**COUNTY OF SAN MATEO
PLANNING AND BUILDING DEPARTMENT**

SUBJECT: EXECUTIVE SUMMARY: Consideration of a Non-Conforming Use Permit, Coastal Development Permit, and Design Review Permit, pursuant to Sections 6133.3b, 6328.4 and 6565.3 of the San Mateo County Zoning Regulations, respectively, to allow construction of a new 1,732 sq. ft., two-story single-family residence, plus a 380 sq. ft. two-car attached garage, located on an existing 4,400 sq. ft. legal non-conforming parcel where the S-94 Combining District requires a minimum parcel size of 10,000 square feet. The project includes extension of Cortez Avenue by approximately 60 feet for project access and a new firetruck turnaround. The Non-Conforming Use Permit is required to allow development on a non-conforming parcel that proposes right and left side setbacks of 7 feet each, where 10 feet is the minimum allowed for each side. No trees are proposed for removal. The project is not appealable to the California Coastal Commission.

County File Number: PLN 2018-00397 (Irfan)

FRONT ELEVATION

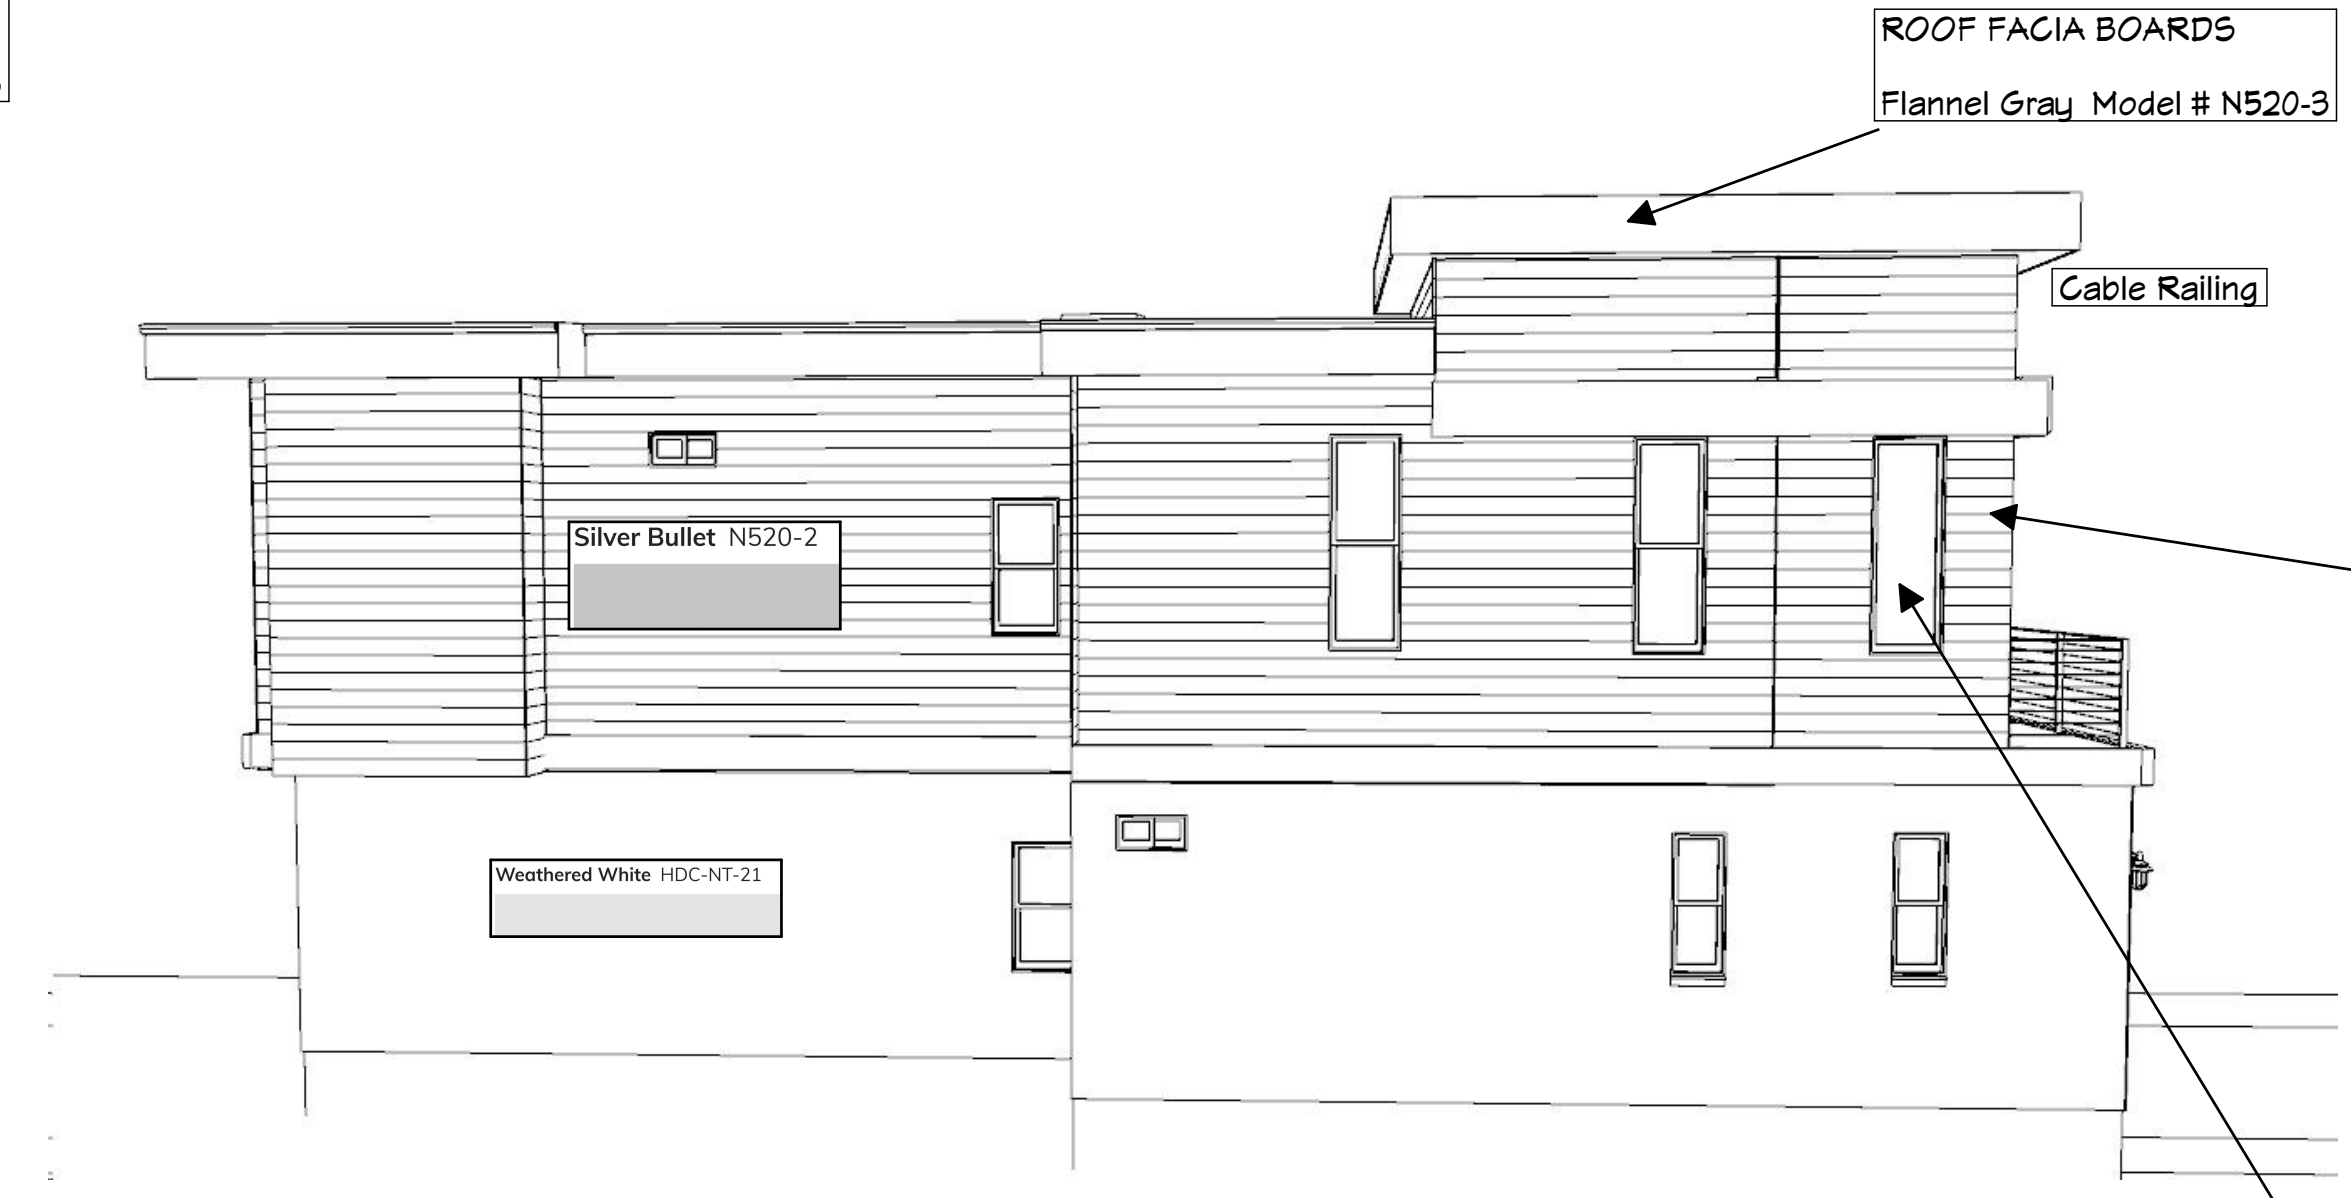
- b. Provide steps down from sliding glass door on east side of house.
 - c. Substitute solid parapet for cable rail at front of roof deck.
 - d. Use lighter shade of stain (lighter than "Early American" Varathane Wood Stain) on all wood surfaces. Please provide a sample of the revised stain color to staff at the building permit stage.

- b. Provide steps down from sliding glass door on east side of house.
 - c. Substitute solid parapet for cable rail at front of roof deck.
 - d. Use lighter shade of stain (lighter than "Early American" Varathane Wood Stain) on all wood surfaces. Please provide a sample of the revised stain color.

Wood Stain
Varathane Early American Stain
266196 -

ROOF and Roof Deck Plan

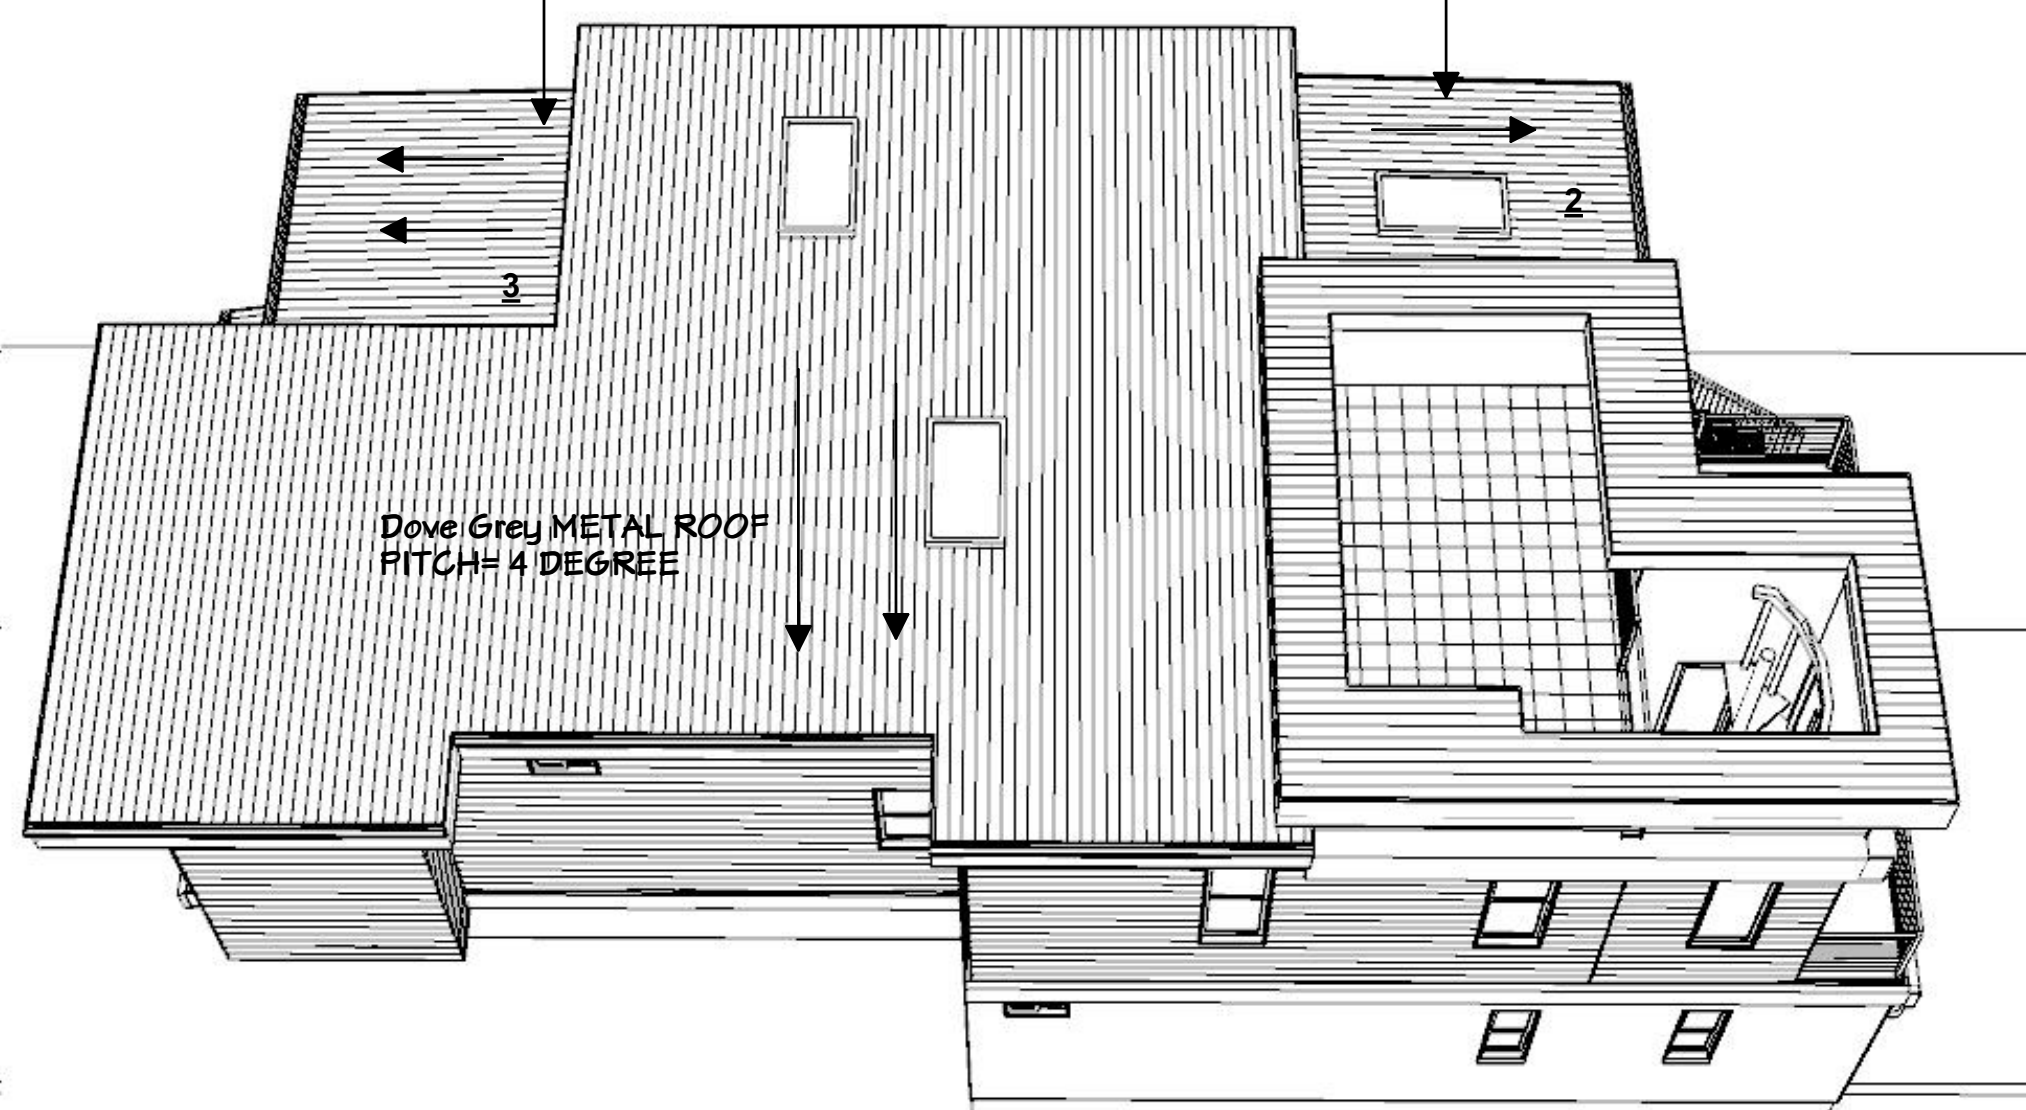
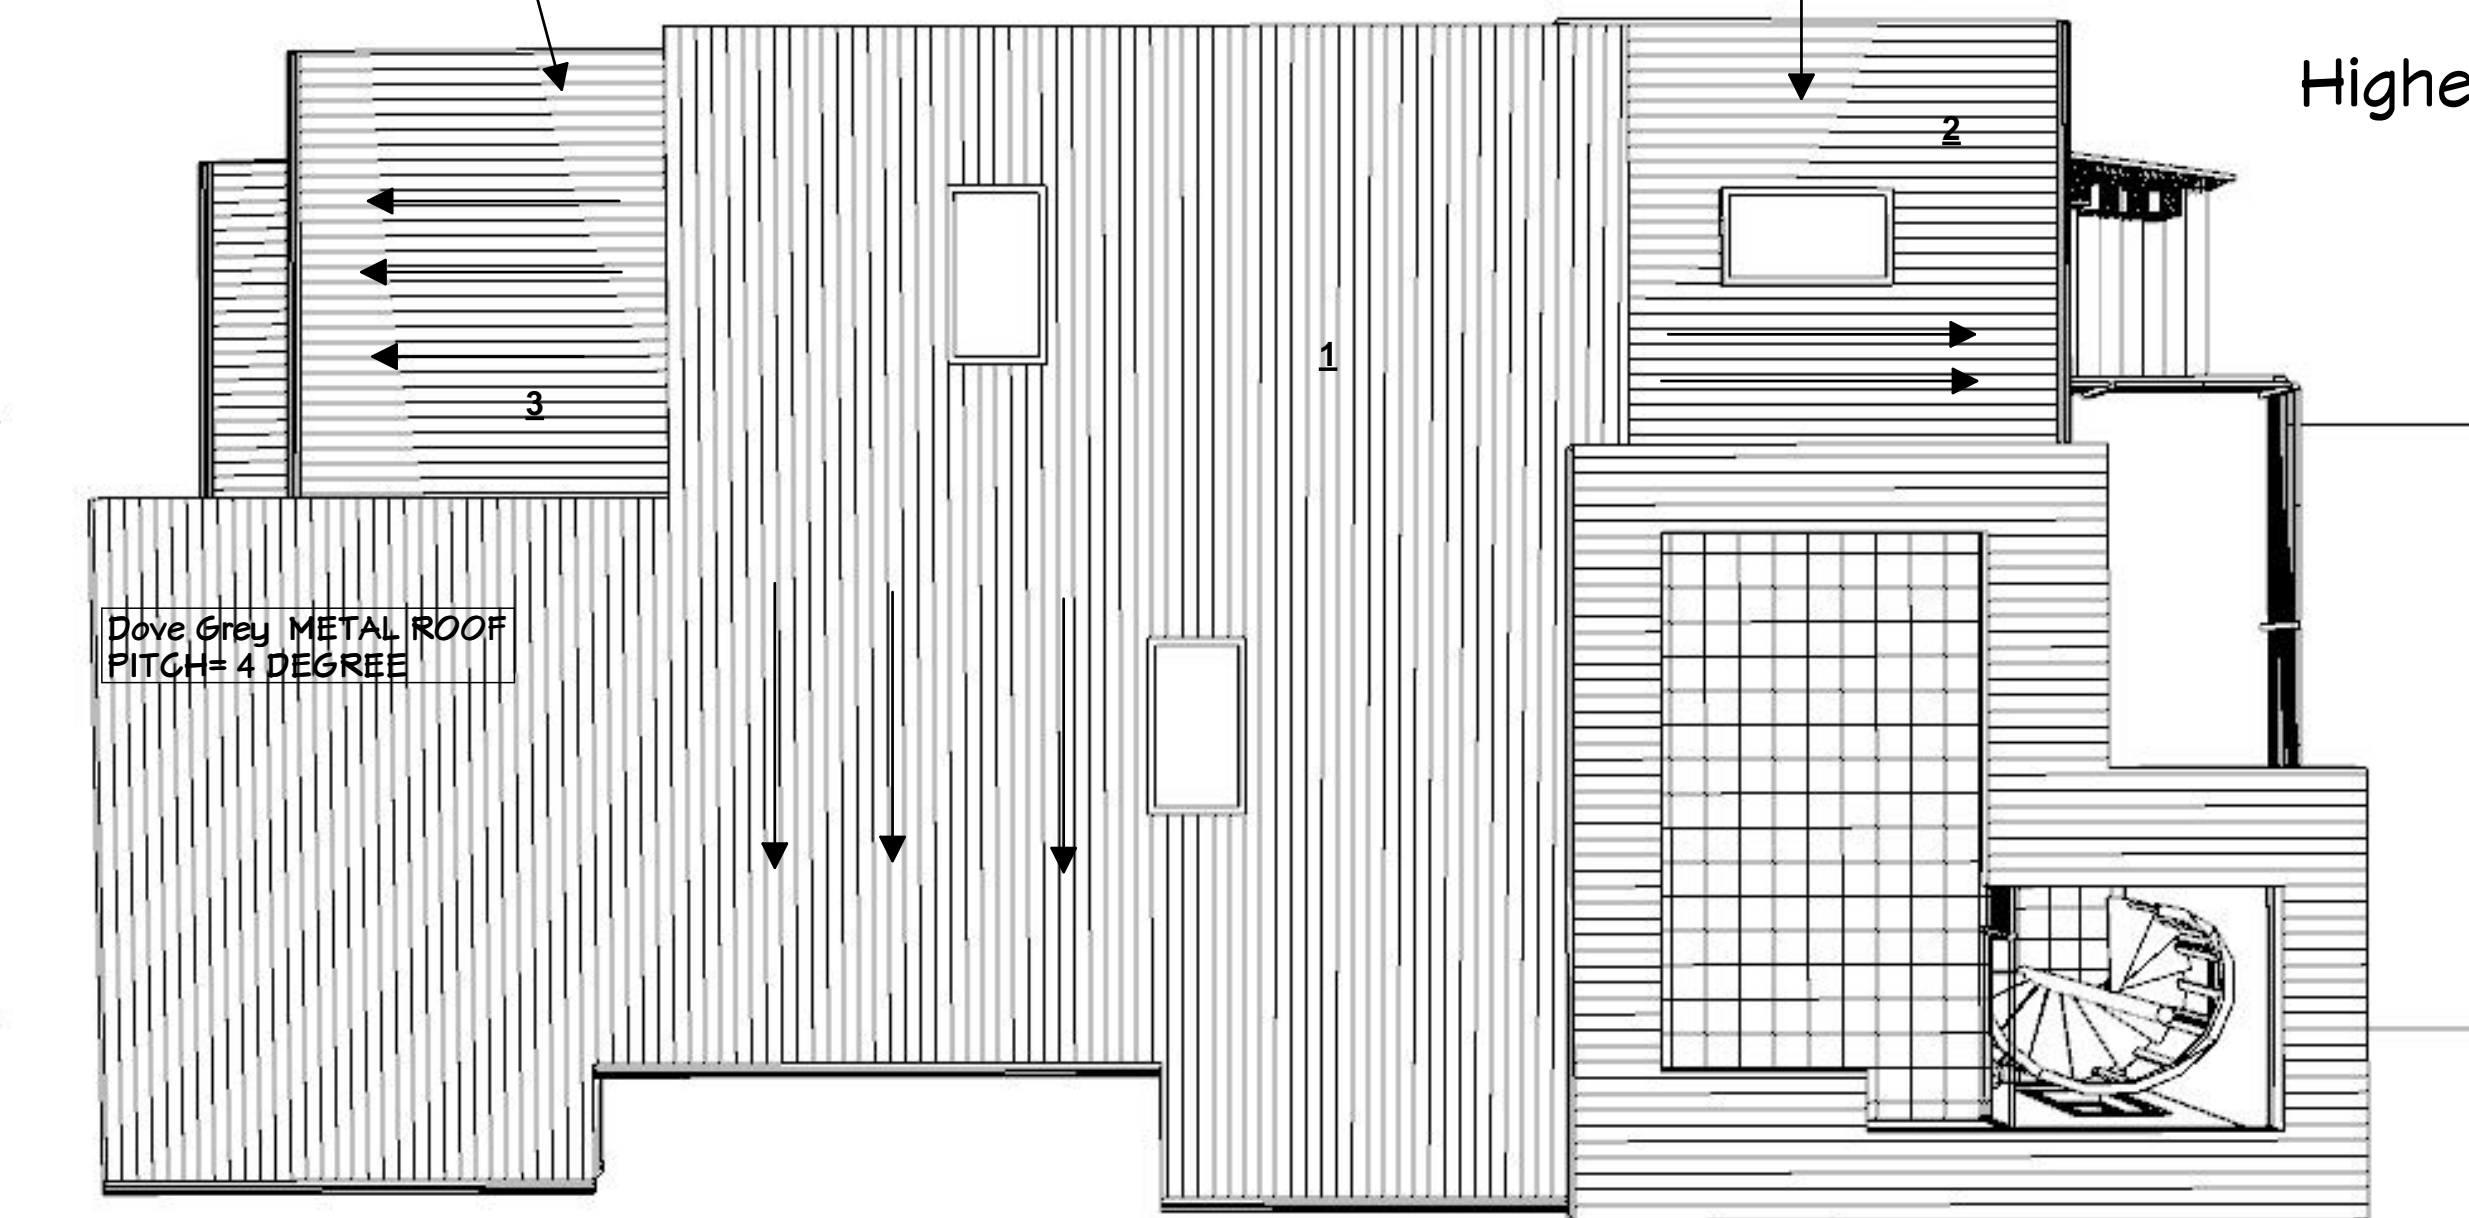
4. The applicant shall indicate the following on plans submitted for a building permit, as stipulated by the Coastside Design Review Committee.
 - a. Reduce roof fascia from 18 inches to 12 inches.

1. The applicant shall indicate the following on the plans submitted for a building permit, as stipulated by the Coastside Design Review Committee:
 - a. Reduce roof fascia from 18 inches to 12 inches.

ROOF FACIA BOARD WIDTH = 18 inches (Box Soffit)
